**State Significant Development Application – Station Site South and Station Site North**

# North Ryde Station Precinct

## Station North and Station South Site - State Significant Development Application

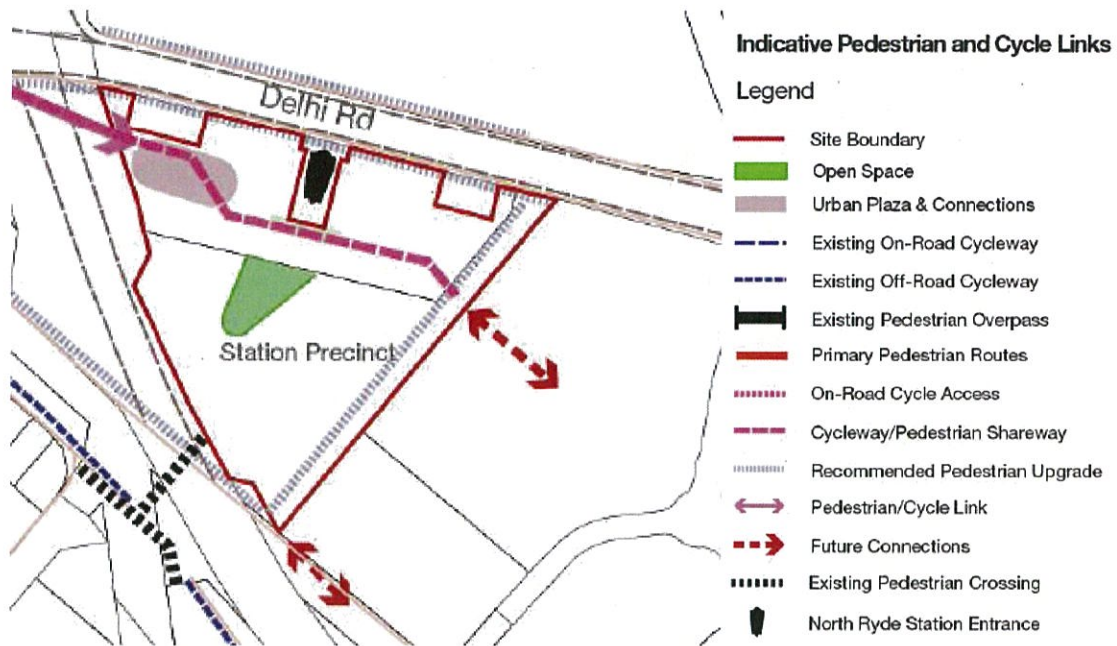
The SSDA includes the delivery of 2 roads. These roads include Station Street (shown in blue below) and Road 38. Road 38 extends from Delhi Road through to Lucknow Road, with only Road 38 North (shown in red below) being delivered under the SSDA. Notwithstanding this, Council is in receipt of a DA for 27-37 Delhi Road which includes Road 38 South (shown in yellow below).

Council does not support the proposed road design. This is as the proposed widths fail to comply with that shown within the North Ryde Station Precinct Development Control Plan 2013 (NRSP DCP 2013). Council's position is that the widths detailed within the NRSP DCP 2013 should be provided. Further detail regarding each road is provided in the following sections.

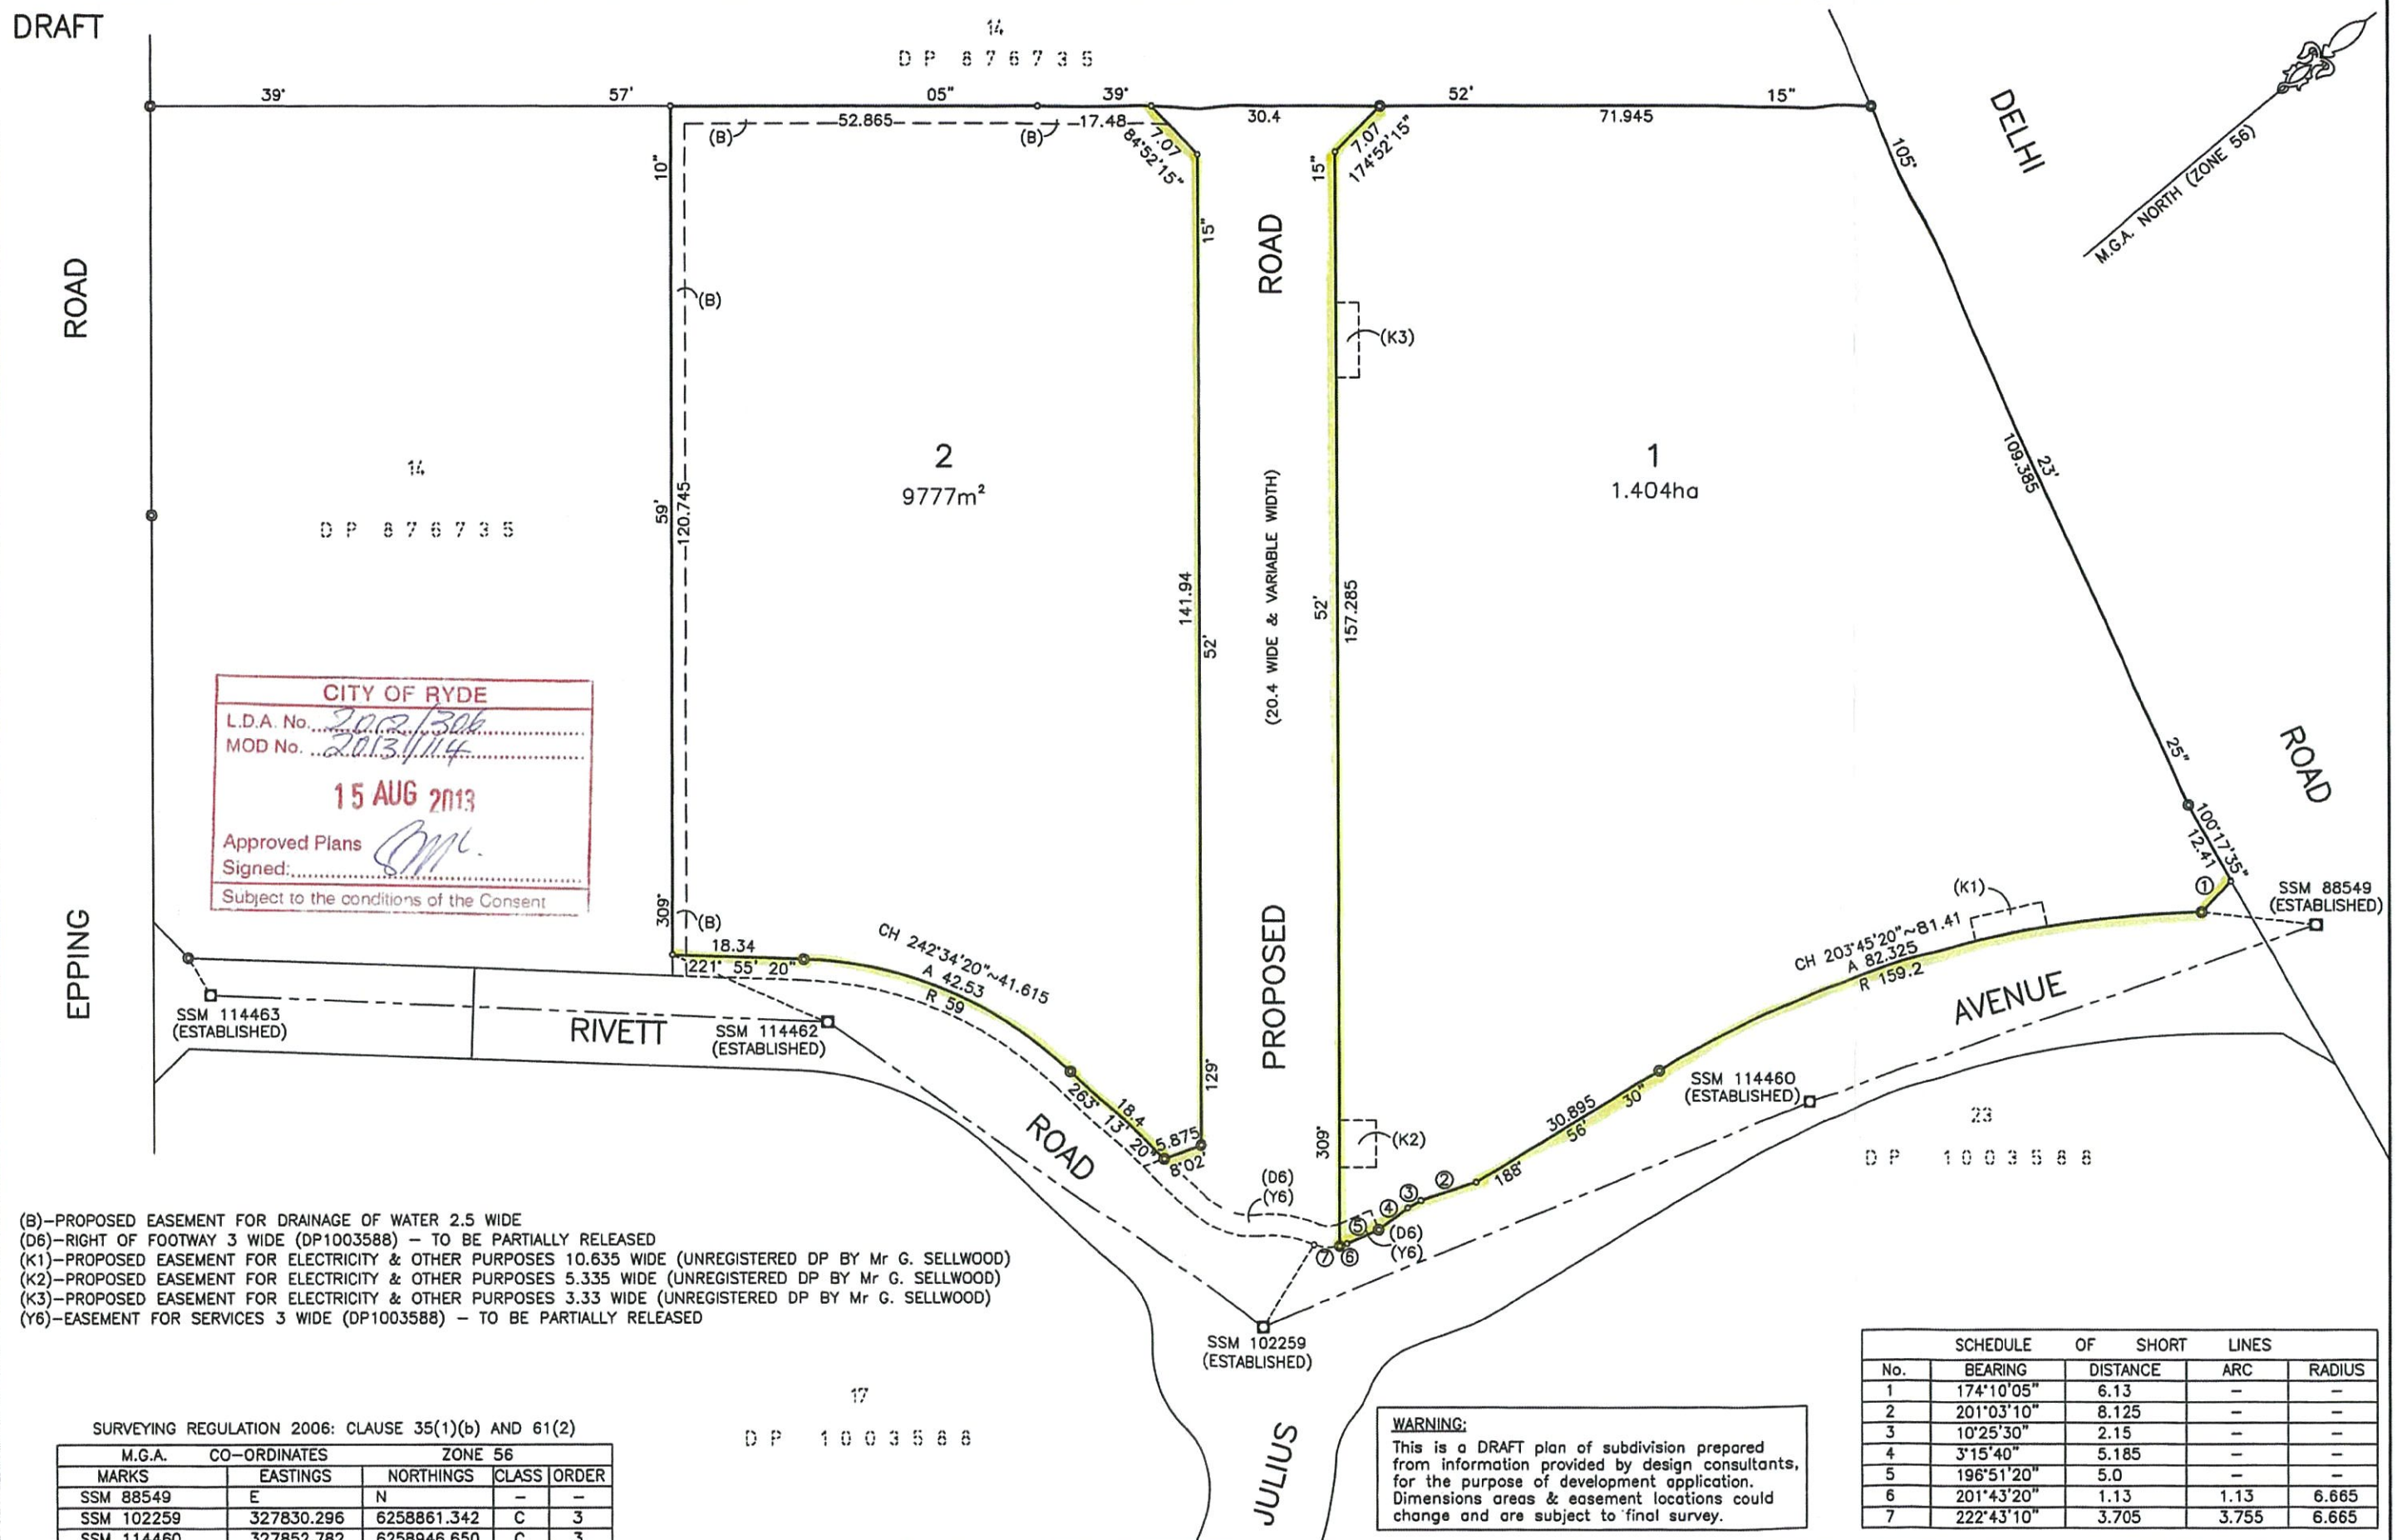
The movement of cyclists must also be addressed. There does not appear to be any details regarding access for cyclists through the proposed roads. This must be clarified. In particular it is noted that Figure 13 of the NRSP DCP identifies a pedestrian / cyclist shareway extending along Station Street and pedestrian upgrade along Road 38. An extract has been provided below.

PLAN OF SUBDIVISION OF LOT 21 IN DP 1003588

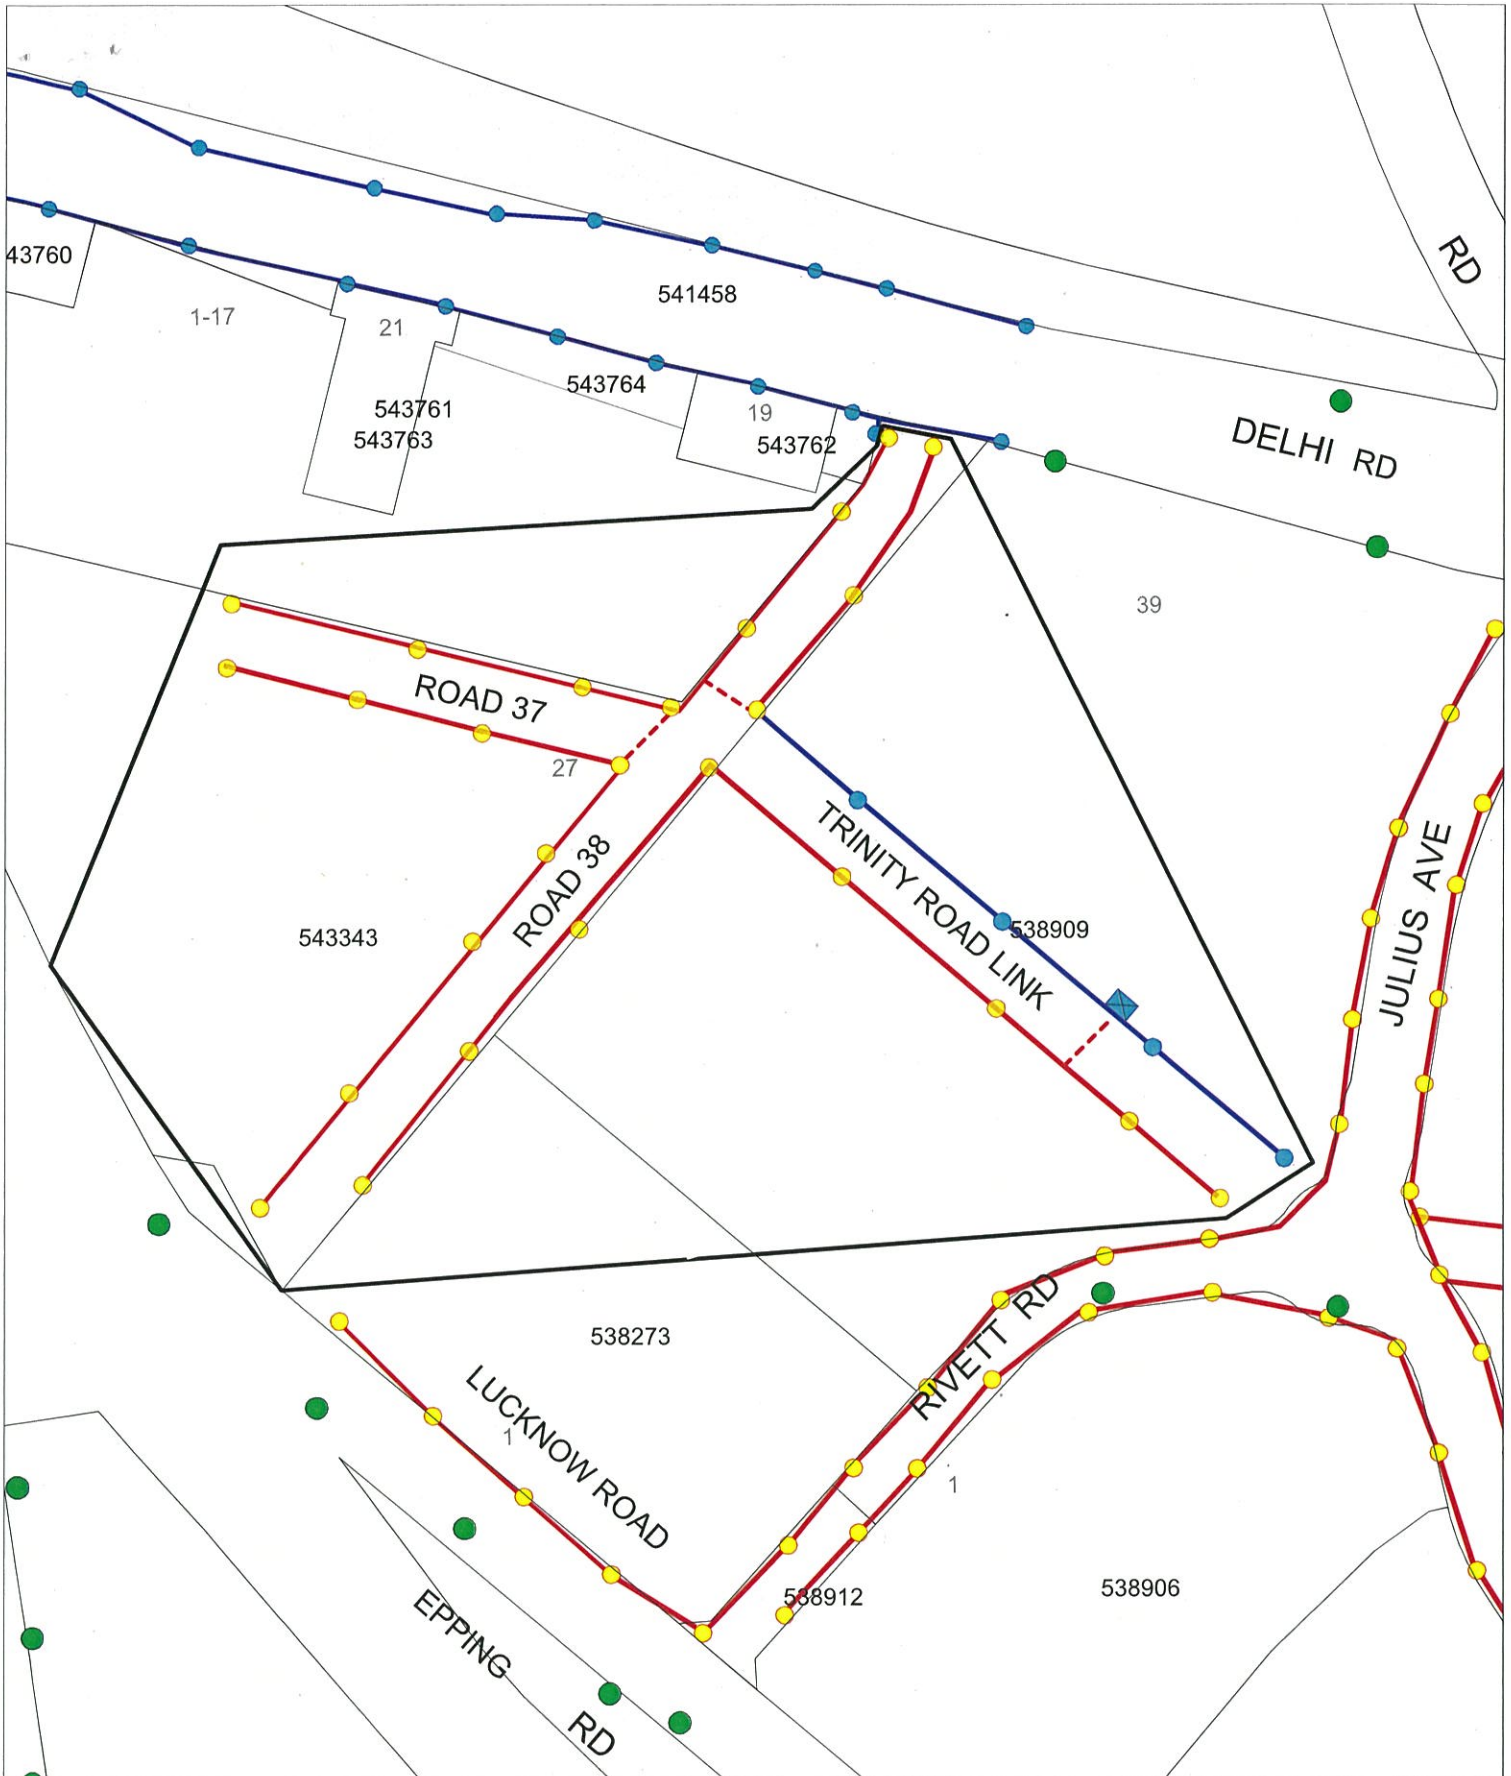
These are identified in DP 1131774, DP 1187161, and DP 104833. It is noted that Drawing Number C0-01 Revision 4 prepared by Robert Bird Group includes a note that details of easements are contained in the Schedule of Easements and Stratum Statements on DP and Title Documents. Whilst this plan shows some of the easements it does not include an easement under DP 104833 which provides access to an existing substation located on the site. This easement must be addressed under any forthcoming development application.
